Quality Control Check Report. Stage: After Finishing Stage III (Apartments)

Flat No	518	Other	←	Sl. No.	42584
Company	MRGV	Project	BRGV	Phase	←
Prepared by	Saikiran	Sign	<i>[Signature]</i>	Date	14-11-2023
Project Manager	Sarwan	Sign	<i>[Signature]</i>	Date	14-11-2023
Previous stage report no.	42107	Report filed and signed by PM		☒ Yes ☐ No	
Checked By MD on		MD Sign		For filling	☐ Yes ☐ No
Recommendation: ☐ Stop further work. Submit ATR on QC report to QC team. Proceed only after recheck by QC. ☐ Stop further work. Proceed with work after submitting ATR on QC report to QC team. ☒ Proceed with further work only after making corrections pointed out in the QC report. ATR not required. ☐ Proceed with further work. ATR not required.

—BLOOMDALE

Details of Additions & Alterations

ELECTRICAL PLAN

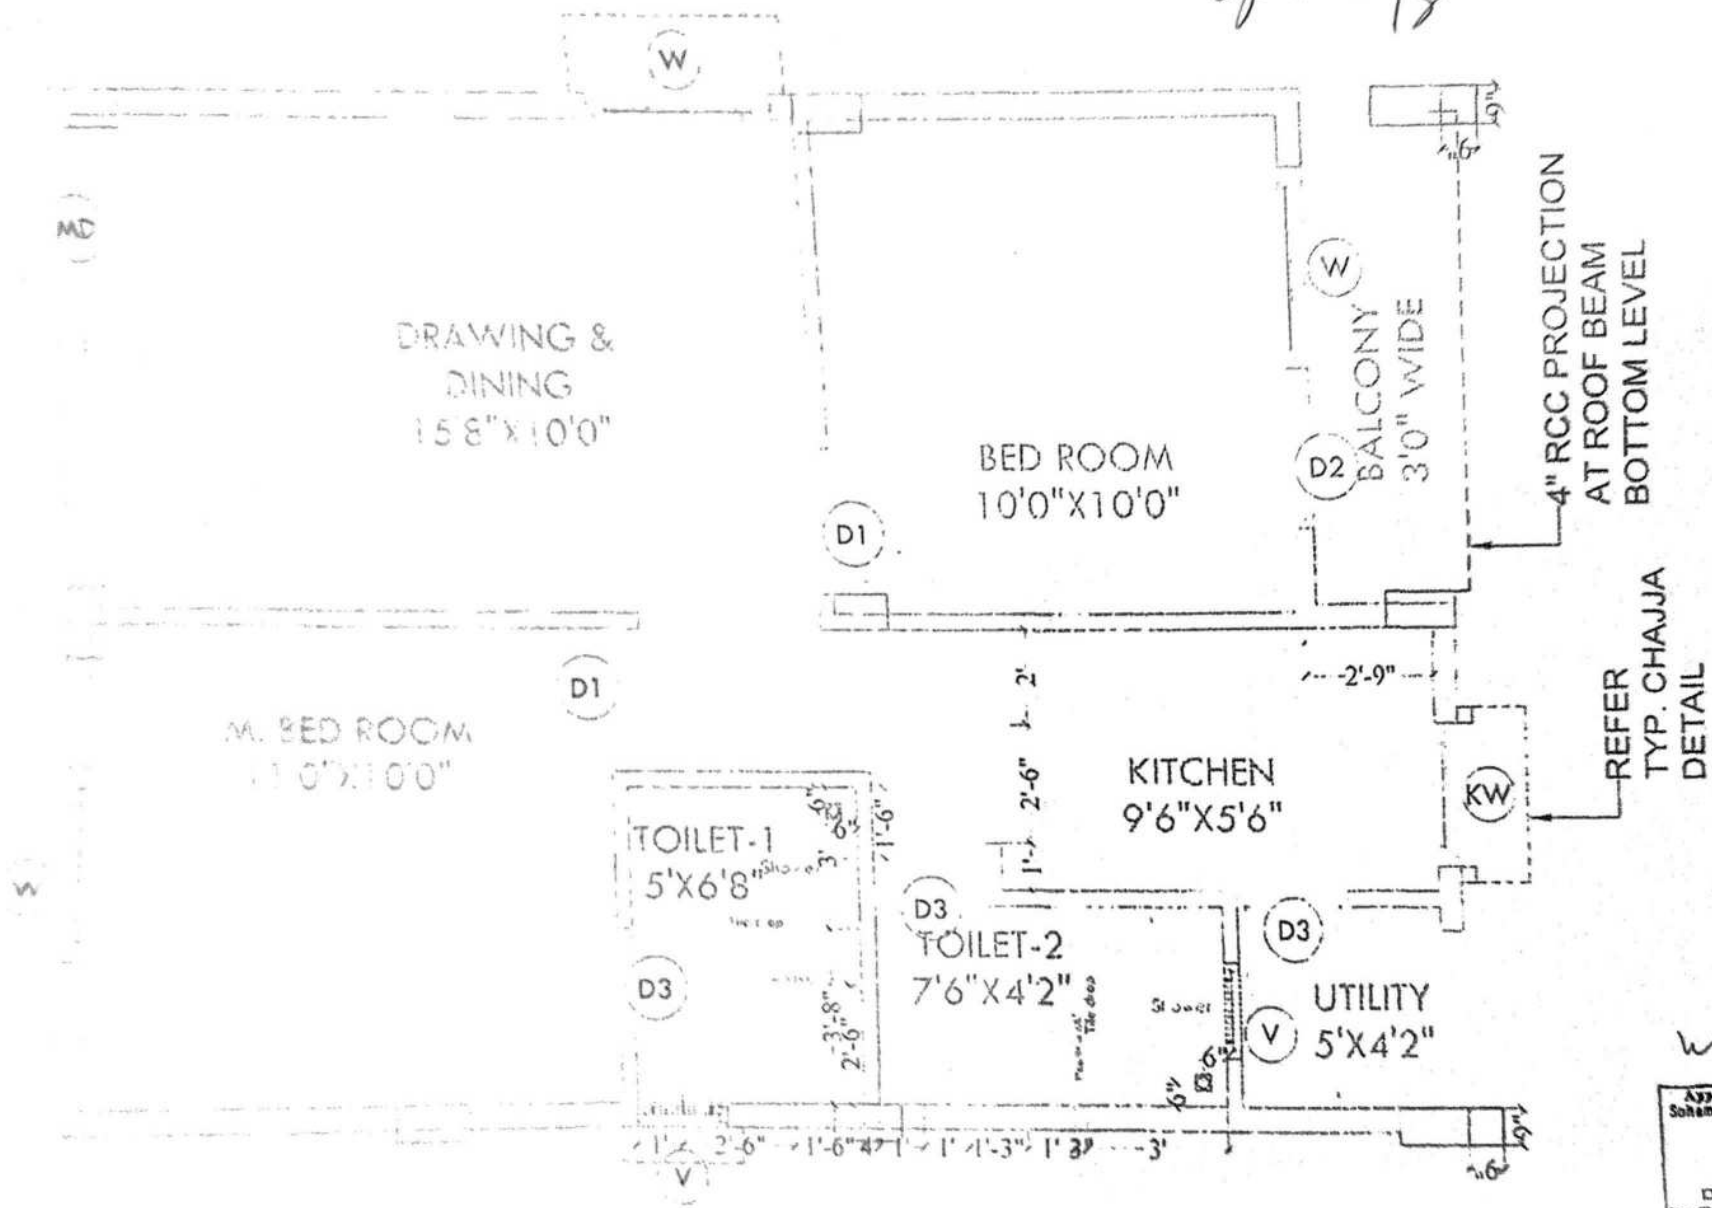
Changes in electrical points: (mark on plan)

- ① 16 amp Extn for kitchen
- ② 16 amp Extn utility.
- ③ Extn pit for T.V. sockets.
